**Revised Interim Measures Work Plan
Sub-Areas 2B and 6B
The Boeing Company, Tract 1
Hazelwood, Missouri**

Re: Response to Comments Received from MDNR and St. Louis Lambert International Airport on the Interim Measures Work Plan Sub-areas 2B and 6B, Dated December 2011, The Boeing Company Tract I Site, Hazelwood, Missouri, MOD000818963

RESPONSE TO COMMENTS

Figure 2-3
Geologic Cross-Section of Sub-Area 2B
Boeing Tract I
Hazelwood, Missouri
(Modified after MACTEC)

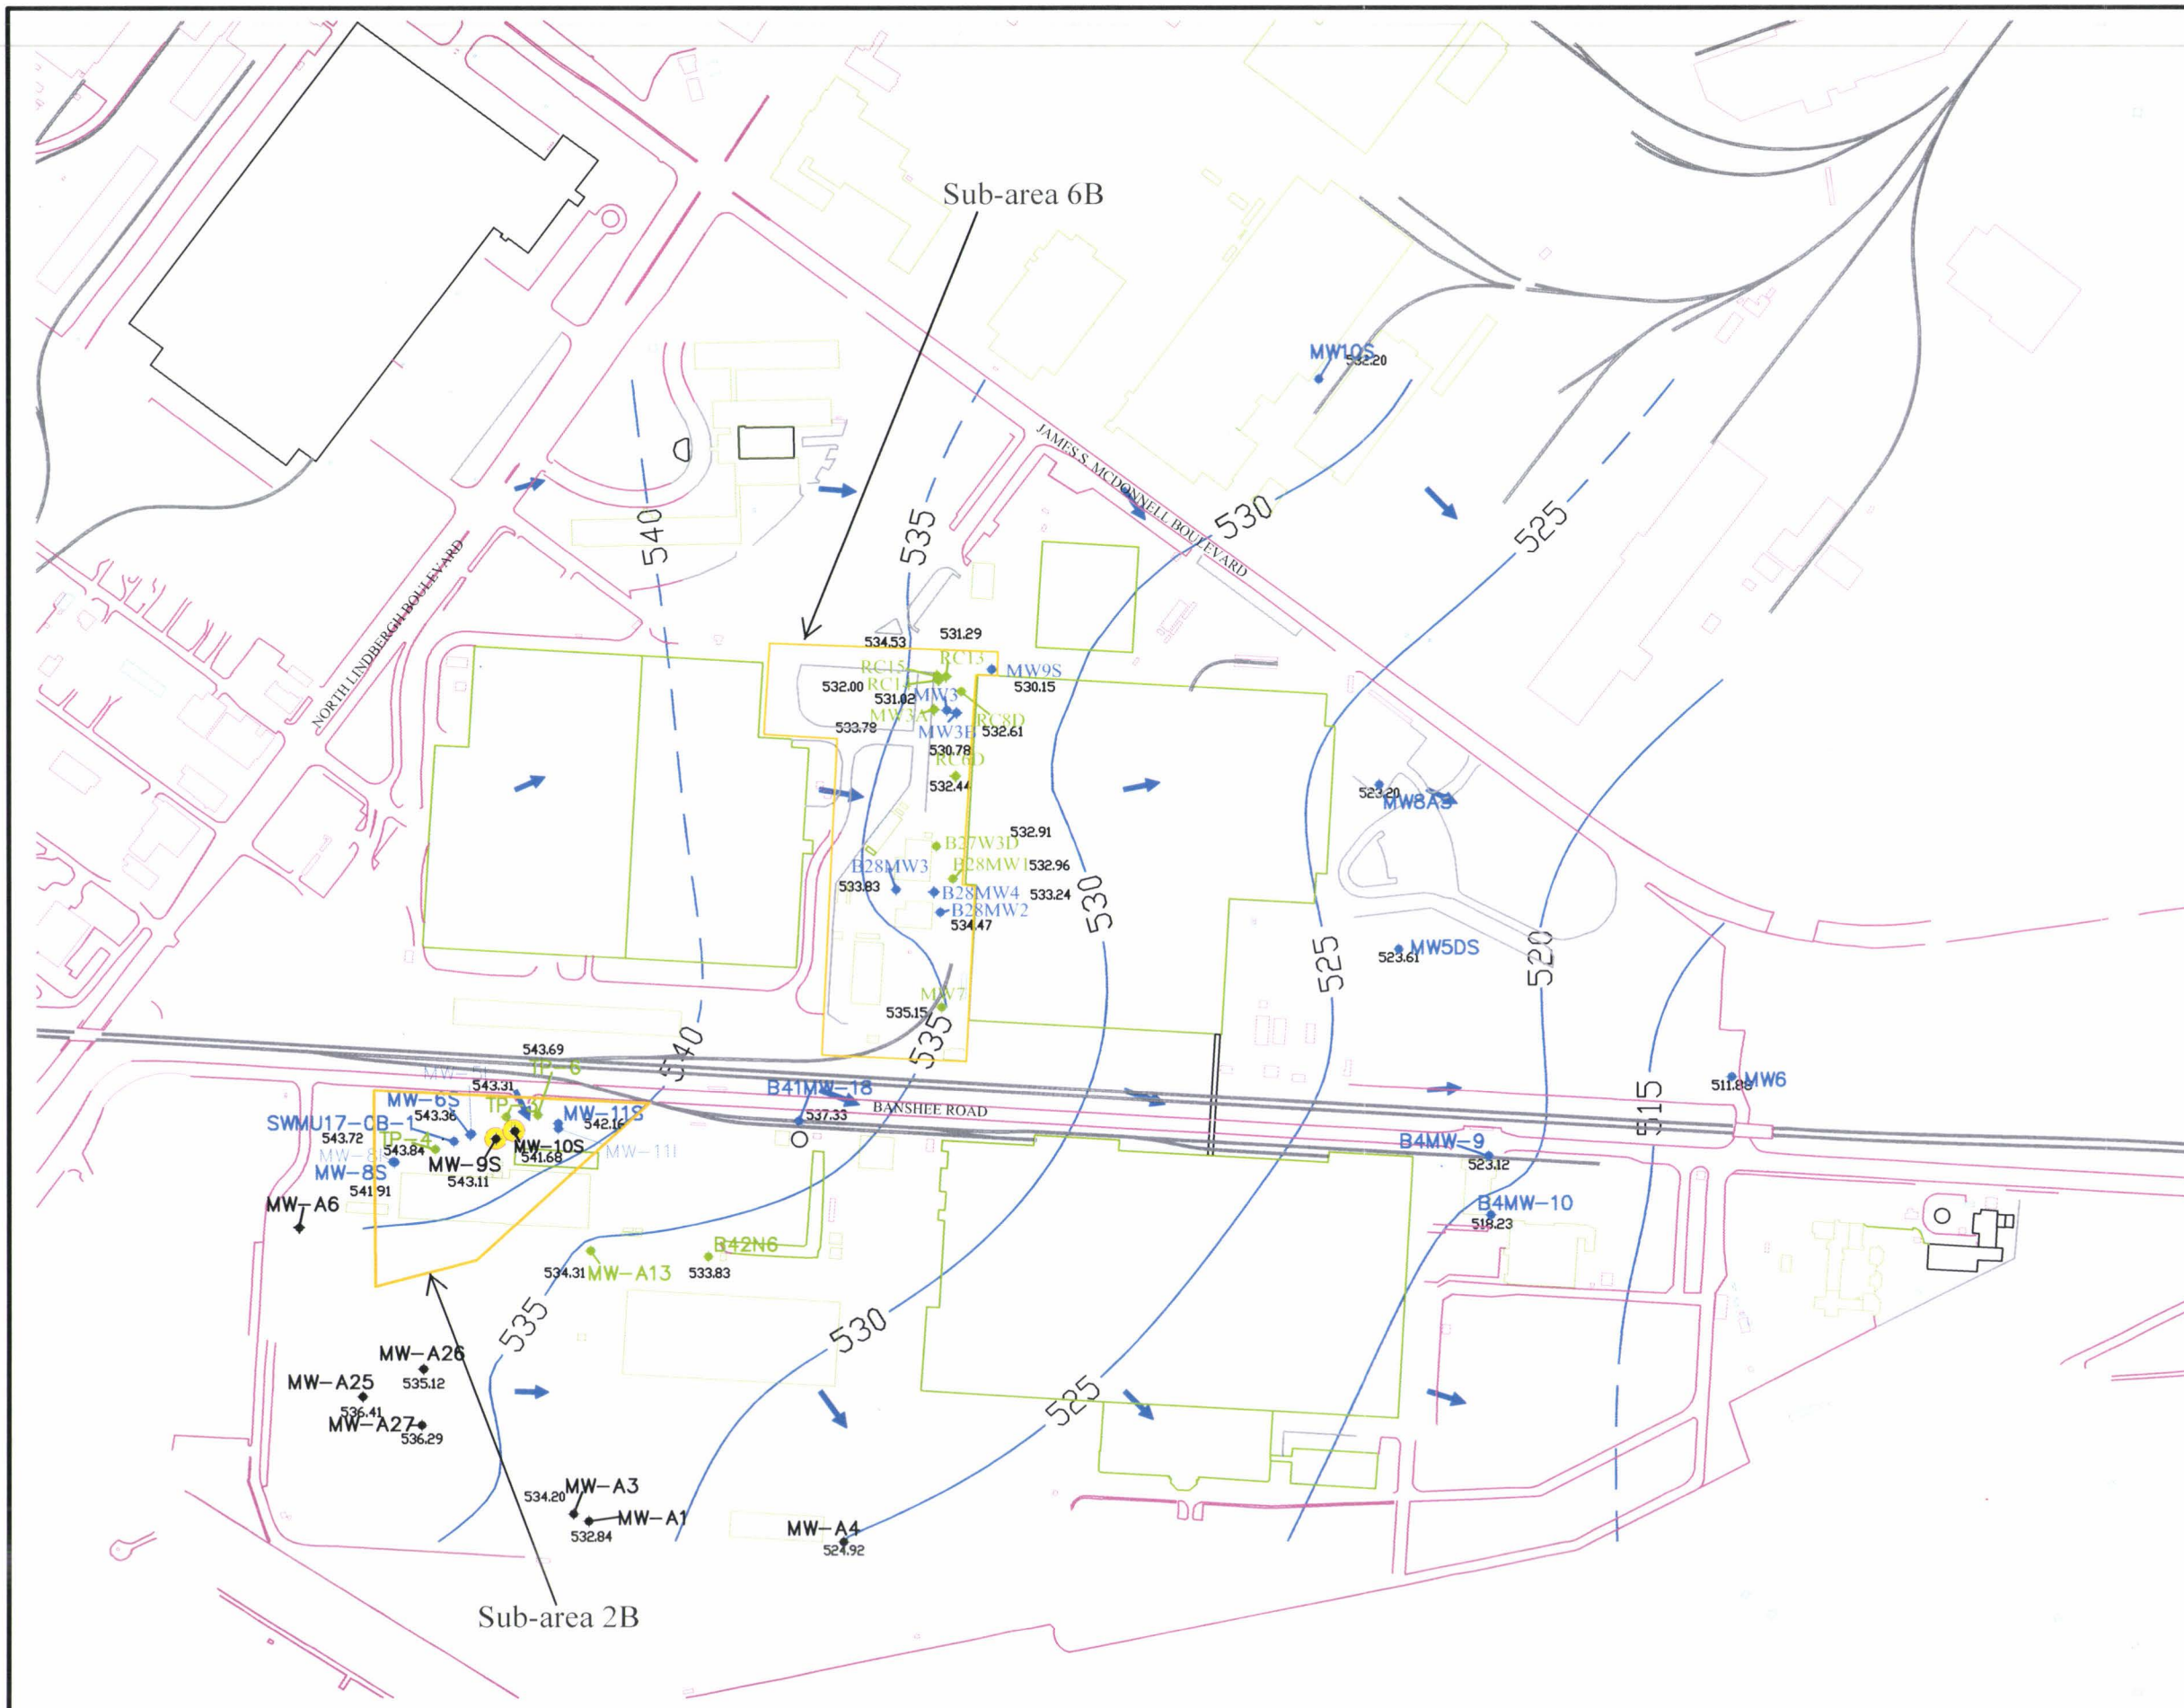
- b. Cross section of site that includes depth to bedrock, depth to water bearing zone(s), depth of injection, area of soil and groundwater contamination, utilities, septic tanks system, etc;

Response: Figures 2-3 and 2-6, geologic cross-sections, have been added for Sub-areas 2B and 6B, respectively.

Figure 2-4(b)
Deep Zone Groundwater Contour Map
(June 15-17, 2011)
Boeing Tract 1
St. Louis, Missouri

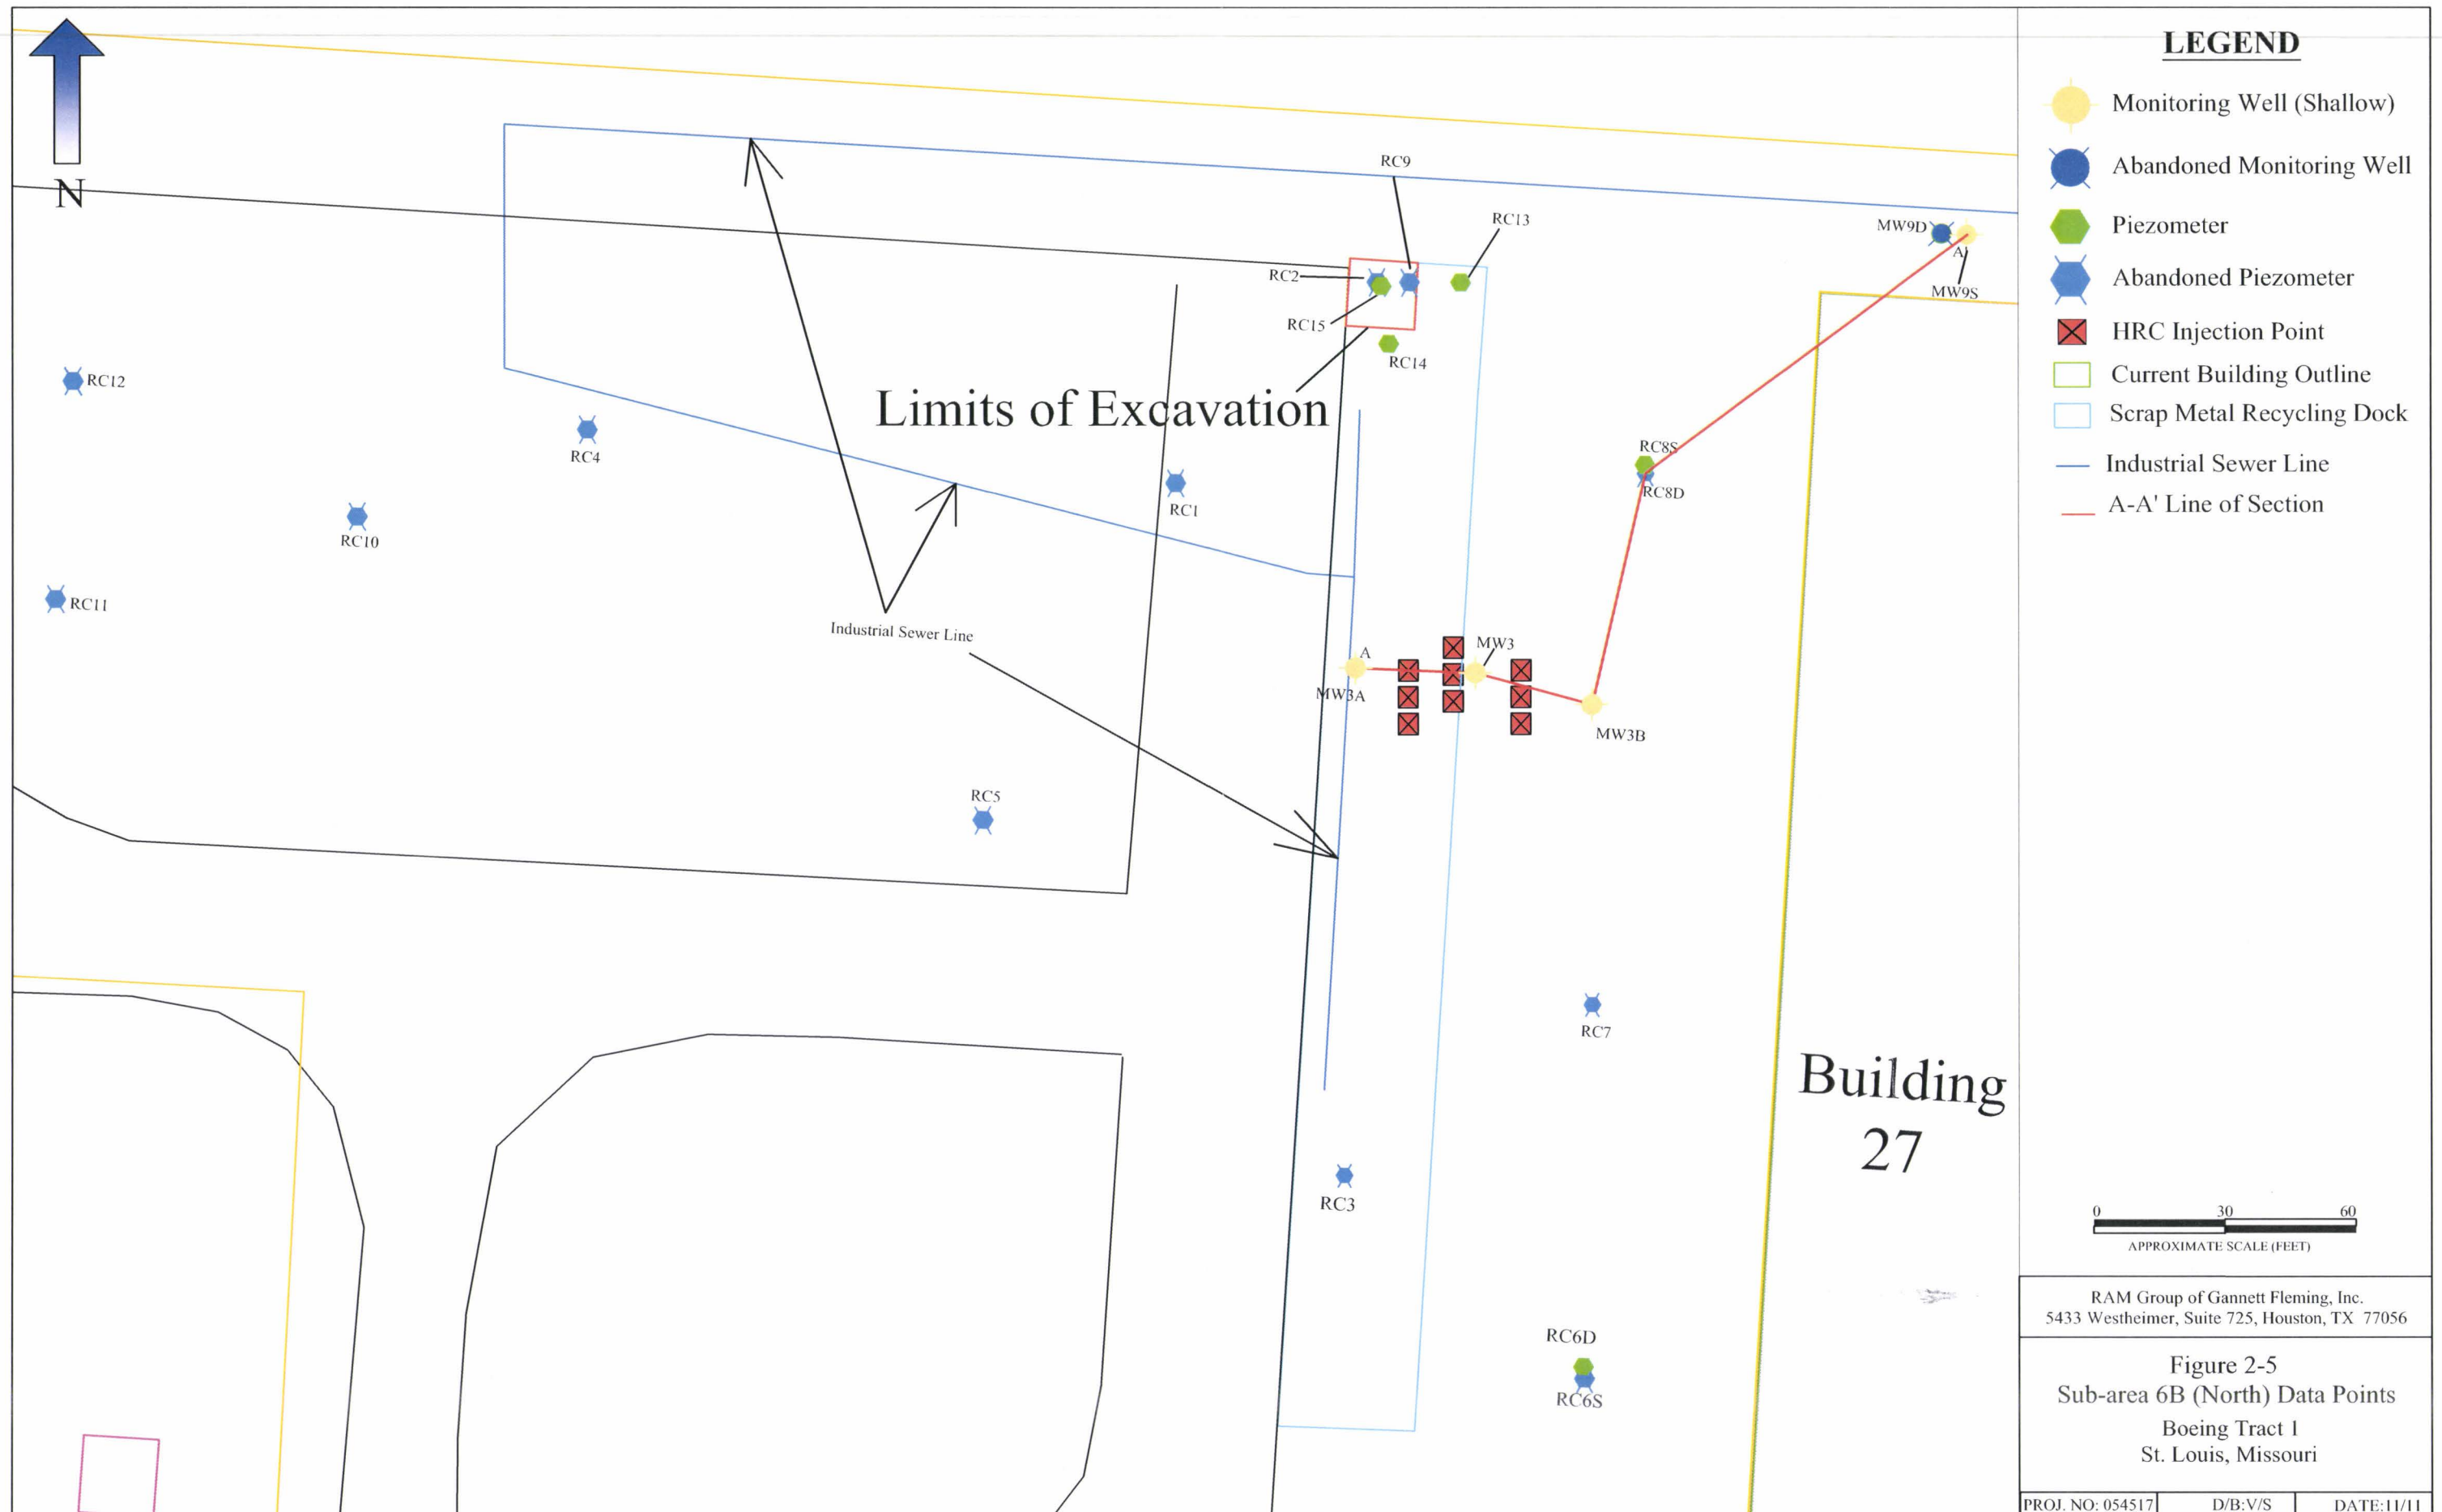
However, the attached "Deep Zone Groundwater Contour Map" [Figure 2-2(b)] demonstrates that:

- 1) The direction of flow of deep groundwater has been defined only by a single well in Tract I South; and
- 2) The attached map [Figure 2-2(b)] supports deep groundwater flow to the south-southeast. Therefore, wells MW-11I and MW-11D do not appear to be downgradient wells. There are no deep wells located south-southeast of MW-5I that can be used to define the extent of impact to deep groundwater.

Response: The statement has been removed. Note that additional intermediate and deep zone monitoring wells are included in the Work Plan as discussed in Section 3.2.1.
